SYDNEY CENTRAL CITY PLANNING PANEL

COUNCIL ASSESSMENT REPORT

Panel Reference	PPSSCC-288
DA Number	DA/873/2021
LGA	City of Parramatta Council
Proposed Development	Demolition, tree removal and construction of a 160 bed Residential Care Facility pursuant to the provisions of State Environmental Planning Policy (Housing for Seniors or People with a Disability) 2004. The proposal is Integrated Development pursuant to the Roads Act 1993. The application will be determined by the Sydney Central City Planning Panel.
Street Address	235-237 Marsden Road, Carlingford
Applicant/Owner	Principal Healthcare Pty Limited
Date of DA lodgement	20 September 2021
Number of Submissions	Five unique submissions
Recommendation	Deferred commencement approval
Regional Development Criteria (Schedule 4A of the EP&A Act)	General Development Over \$30 Million Cost of Construction proposed = \$45,243,219.00
List of all relevant s4.15(1)(a) matters	<ul style="list-style-type: none">• Environmental Planning and Assessment Act and Regulations• Roads Act 1993.• State Environmental Planning Policy (Resilience and Hazards) 2021.• State Environmental Planning Policy (Biodiversity and Conservation) 2021.• State Environ

Location

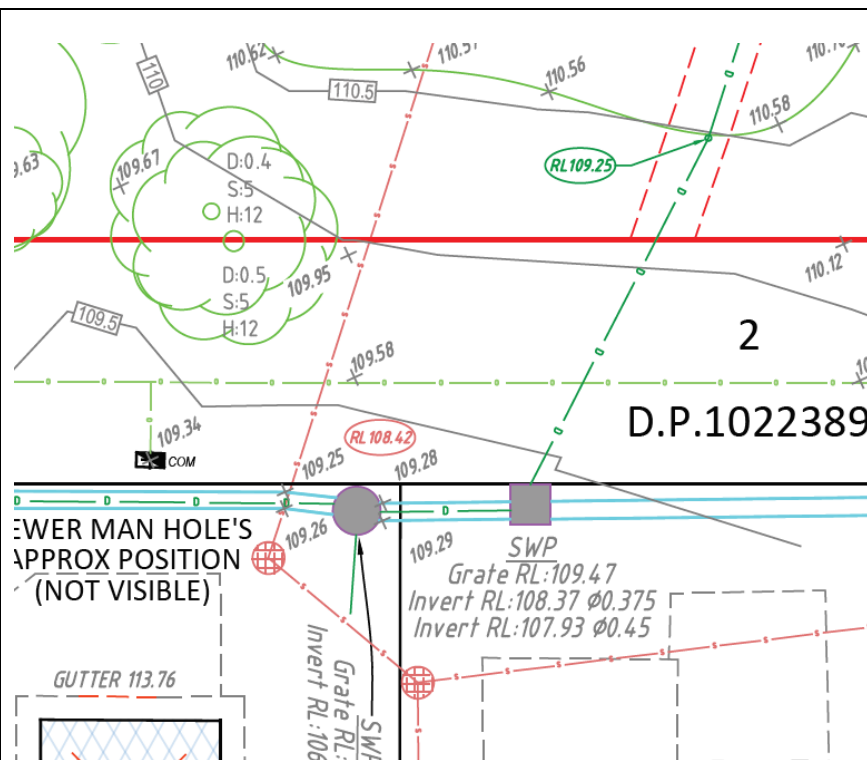
The applicant has not provided enough detail regarding location, capacity of the existing pipe or condition of the existing pipe in the existing easement over the downstream properties. The site is also not a beneficiary of the easement. They are currently in talks with TfNSW (the owner of the easement over the subject site)

The easement owned by TfNSW currently runs through the site and exists through the south of the site. Approval from TfNSW is currently being sought to relocate the easement in the site so that it wraps around the proposed building. After the site the easement runs to a junction pit in a downstream property and there are no further details provided. The applicant has also provided no indication that they have contacted downstream property owners requesting to connect into the easement.

Capacity and Condition

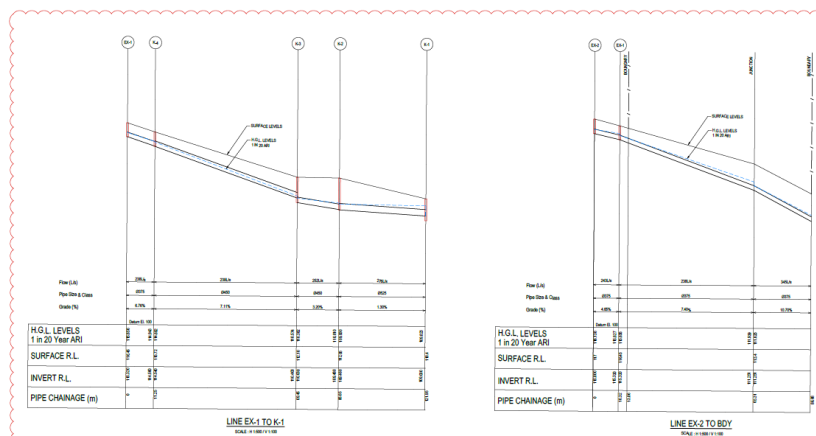
As per Council's Engineering Design Guidelines Section 2, Part 3.1, "The OSD system shall function during all storm events up to and including the 100 year ARI storm event." Due to this requirement, the capacity of the pit and pipe system must be designed to cater for the 1% AEP storm event to where the system connects to a legal discharge point. The applicant has only checked the capacity of the pipe for the 5% AEP storm event for a portion of the easement, not to the legal discharge point. Details on the condition of the pipe were only provided where the pipe is proposed to be relocated.

If the pipeline that the applicant proposes to utilise requires to be upgraded, Council needs to be certain that it can be completed.

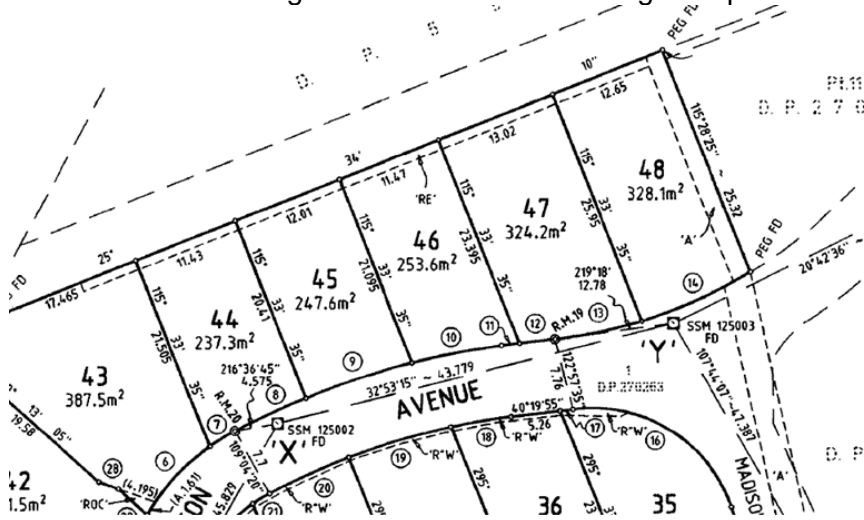
- As there has not been an assessment of the downstream system, Council can only assume that the downstream flood level is at the surface level of connection point to the existing system at RL 110.4, severely drowning the OSD system.
- Music model did not incorporate OSD bypass area
- Courtyard is a trapped low point, which in the event of a system failure cannot drain.

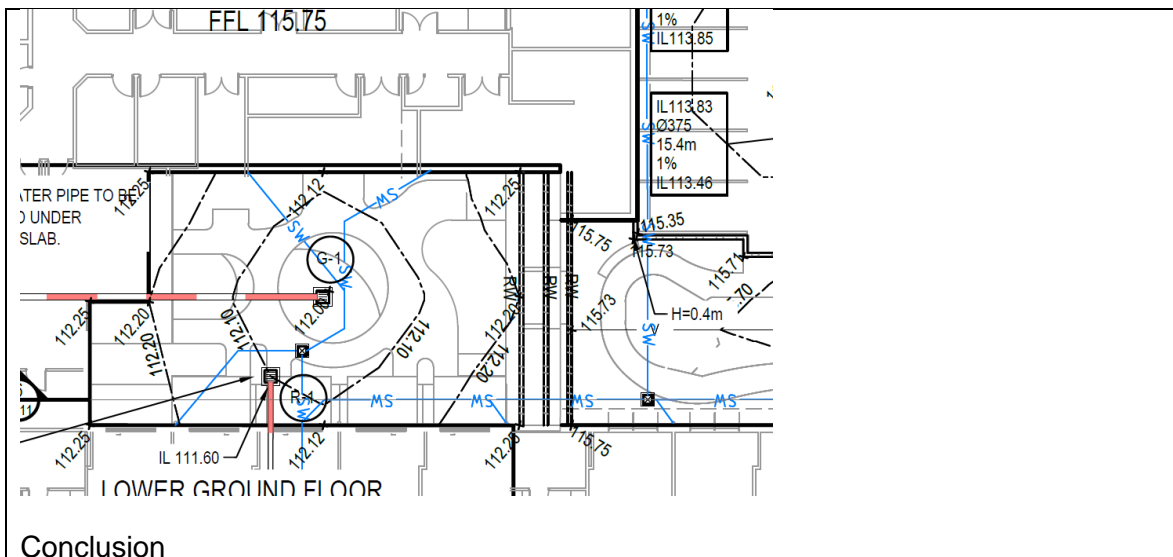
- Site flows are not directed to legal discharge point.

The subdivision plans for Dalmar Estate (private estate downstream of the site) were reviewed to see how the subdivision drained external flows due to the applicant's reluctance to assess the capacity of the pipe in the easement and its condition. After this review, deferred commencement conditions have been applied for the missing information and shortfalls of the concept plans.

The pipe that the site is proposing to connect to has a design capacity of 677 L/s and there is a box channel (min capacity of 170 L/s) that could receive emergency overflows from the system. The existing subdivision had designed to direct external flows to Council's stormwater infrastructure up to the 5% AEP storm event of the subject site.

There is also opportunity for emergency overland flows to make their way to Mulyan Avenue via an existing easement that runs through the private estate.
